**SUNDRY NOTICES AND REPORTS ON WELLS**  
*Do not use this form for proposals to drill or to re-enter an abandoned well. Use form 3160-3 (APD) for such proposals.*

8. Well Name and No.  
RED HILLS UNIT 5

9. API Well No.  
30-025-35112-00-S1

**\*\* BLM REVISED \*\* BLM REVISED \*\* BLM REVISED \*\* BLM REVISED \*\* BLM REVISED \*\***

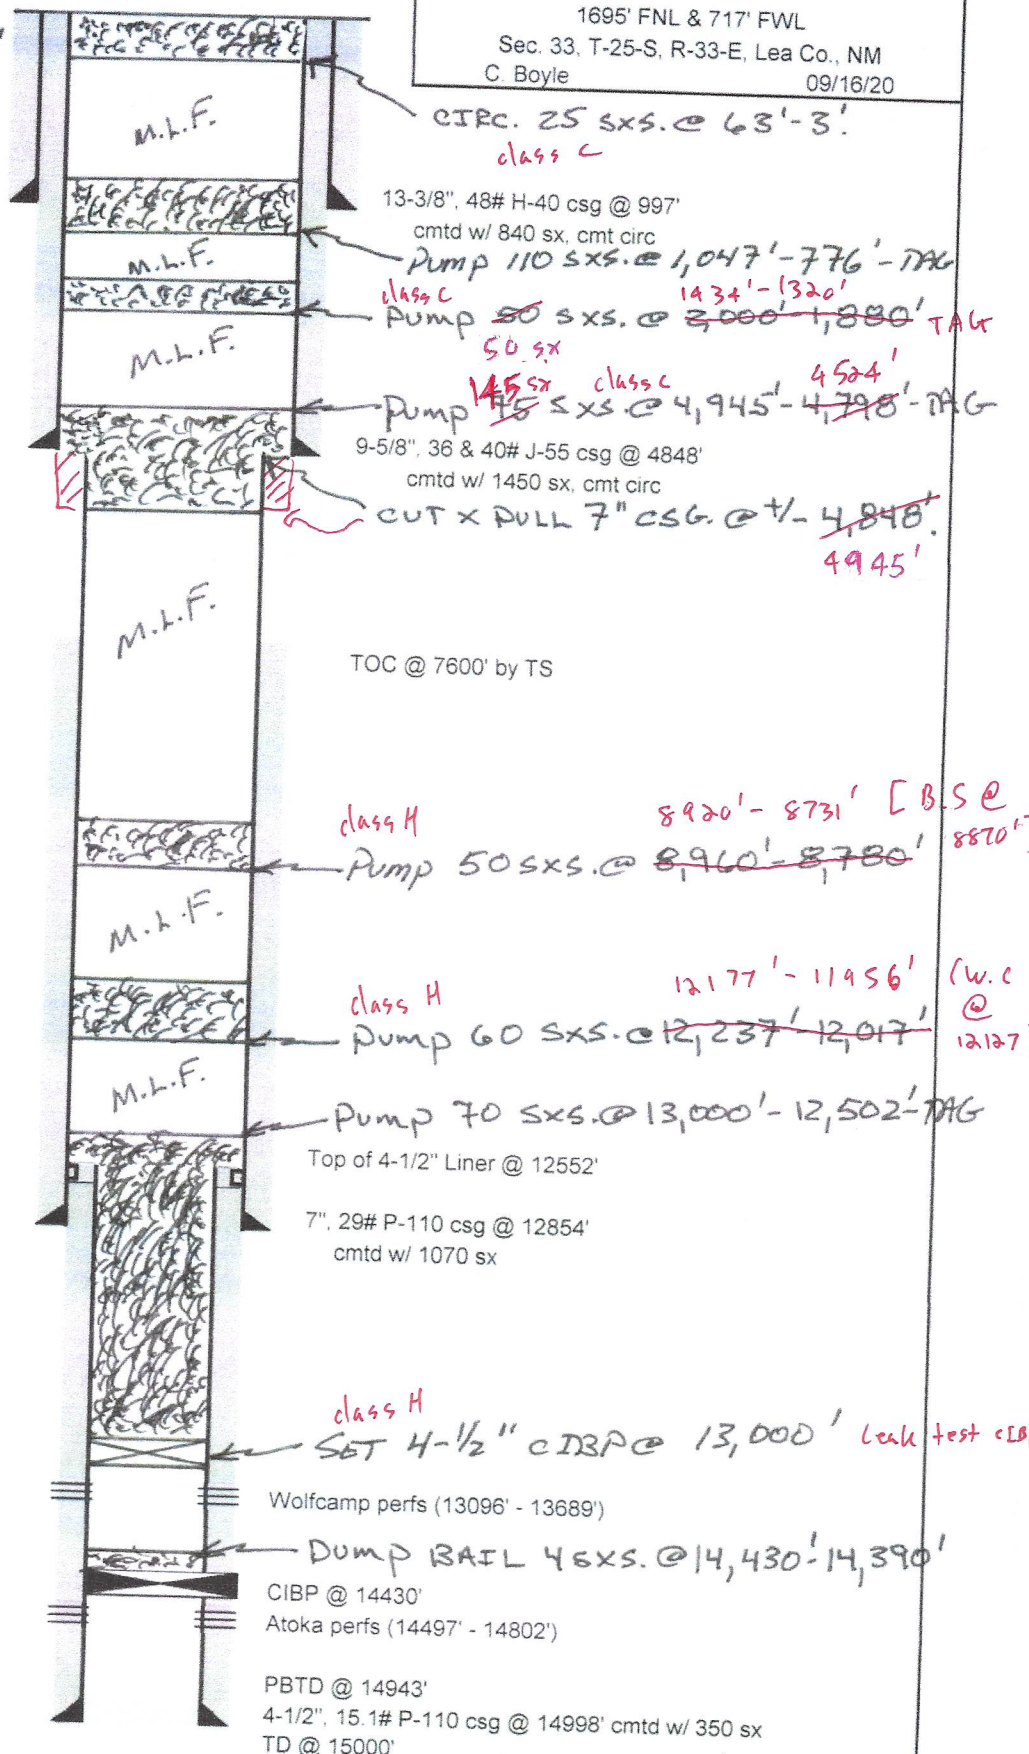
- 3) CIRC. WELL W/ M.L.F.; PUMP 60 SXS.CMT. @ 12,237'-12,047' (T/WLCP.). *Leak test CIBP, class H*
- 4) PUMP 50 SXS.CMT. @ 8,960'-8,780' (T/BNSG.). *8920'-8731, class H*

- 5) CUT X PULL 7" CSG. @ +/- ~~4848~~ *4945'*
- 6) PUMP ~~75~~ *75* SXS.CMT. @ 4,945'-4,798' (T/DLWR., 7" CSG. CUT, 9-5/8" CSG. SHOE); WOC X TAG. *4945' - 4524', class C, TAG, 145x*

- 7) PUMP 50 SXS.CMT. @ 2,000'-1,880' (SPACER PLUG). *1434' - 1320' TAG class C 50 SX*
- 8) PUMP 110 SXS.CMT. @ 1,047'-776' (13-3/8" CSG. SHOE, T/SALT/ANHY.); WOC X TAG.

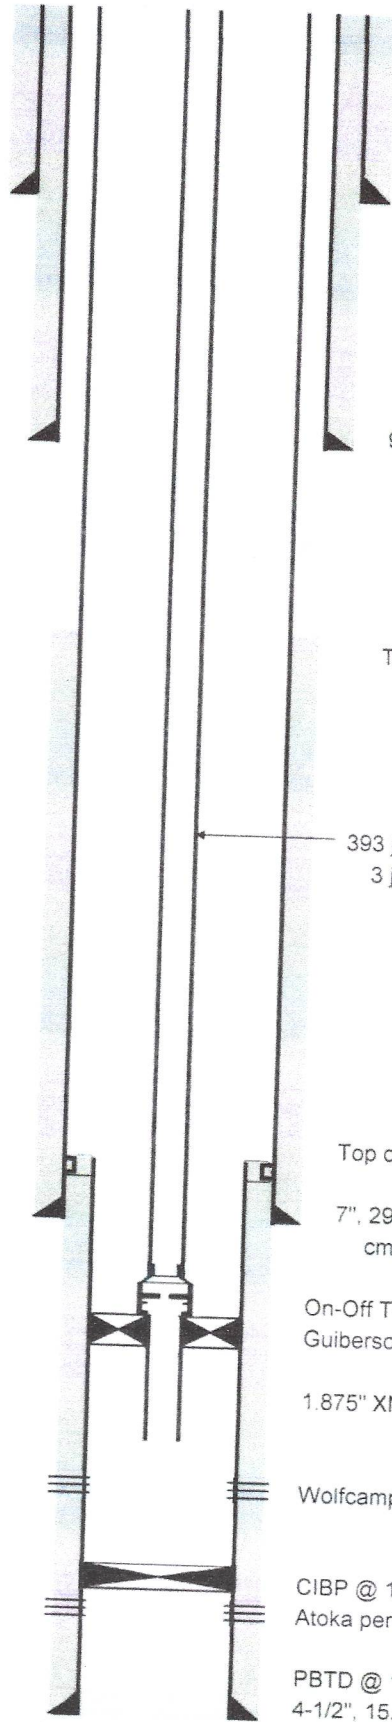
b. salt @ 4621' 1384'  
 T/SALT/ANHY ~ 826'  
 T/DLWR. ~ 4,895'  
 T/BNGR. ~ 8,870'  
 T/WLCP. ~ 12,127'  
 T/CANY. ~ 14,032'  
 T/STWN. ~ 14,169'  
 T/ATOKA. ~ 14,371'

class H 8920' - 8731' [B.S. @ 8870']  
 Pump 50 SXS. @ ~~8960'~~ 8780'

class H 12177' - 11956' (w.c @ 12127)  
 Pump 60 SXS. @ ~~12237'~~ 12017'

Pump 70 SXS. @ 13,000' - 12,502' TAG  
 Top of 4-1/2" Liner @ 12552'

class H SET 4-1/2" CIBP @ 13,000' Leak test CIBP

DUMP BAIL 46XS. @ 14,430' - 14,390'

class C  
 Pump 110 SXS. @ 1,047' - 776' TAG  
 class C Pump 50 SXS. @ ~~2000'~~ 1,880' TAG  
 class C Pump 45 SXS. @ 4,945' - 4,798' TAG  
 CUT X PULL 7" CSG. @ +/- 4,848' 4945'
